CLARIFICATION OF ADDITIONAL INFORMATION REG. REF. SD22A0126

CLARIFICATION OF ADDITIONAL INFORMATION

JOB	RESIDENTIAL DEVELOPMENT AT GRANGE ROAD, RATHFARNHAM, DUBLIN 14
CLIENT	FIRST STEP HOMES LTD
DATE	SEPTEMBER 2022
DRN	BD
SCALE	1:100@A0
DRAWING TITLE	PROPOSED ELEVATIONS NORTH WEST, NORTH, SOUTH EAST AND SOUTH WEST
CHECKED	PM
DRAWING NUMBER	2020_134
REVISION	B
	3.1.201

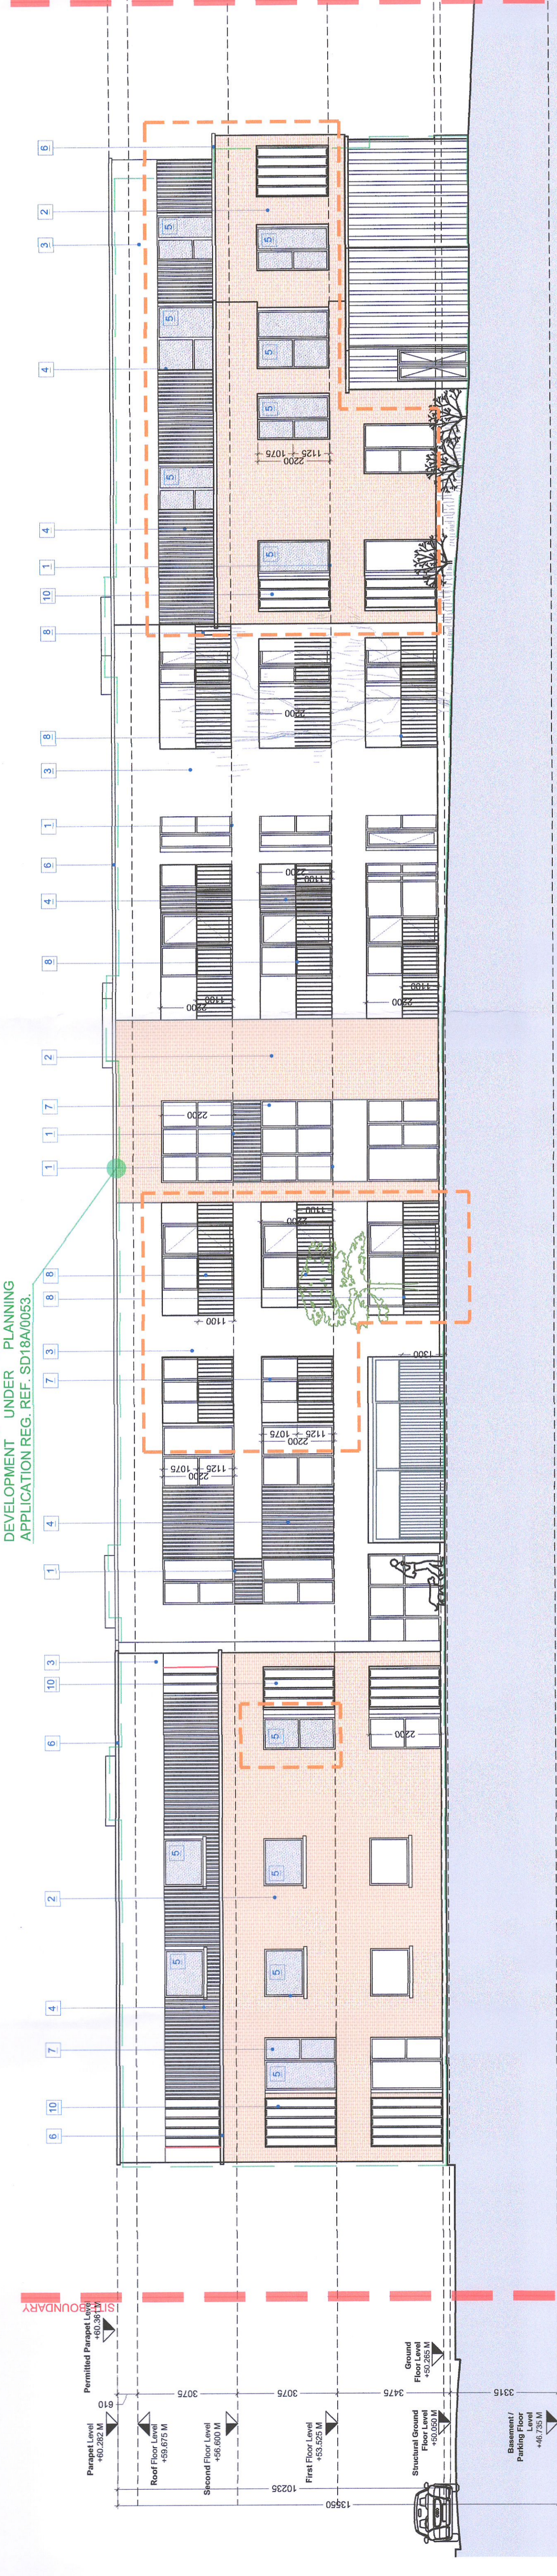
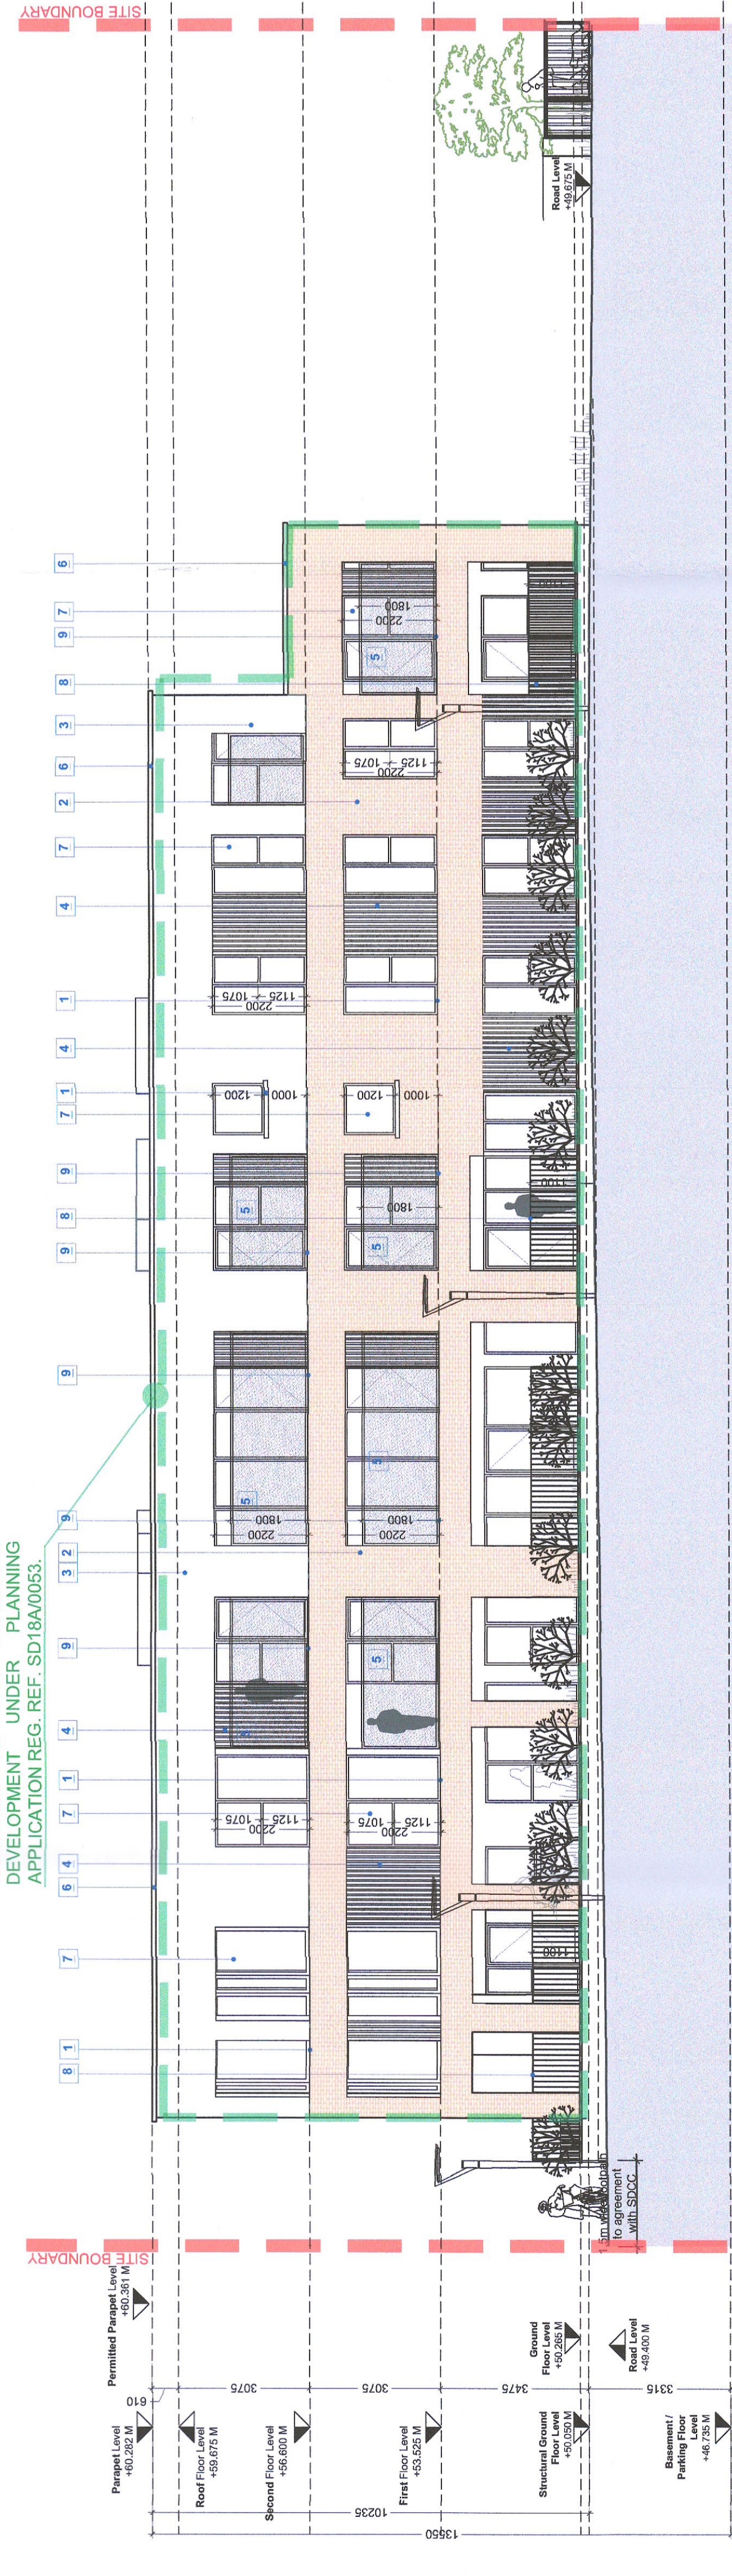
REV	DATE	DRN	NOTES
B	06.09.22	BD	CHANGES TO WINDOWS AS PER CLARIFICATION OF ADDITIONAL INFORMATION
A	11.07.22	BD	CHANGES TO THE WINDOWS AS PER REVISED FLOOR PLANS
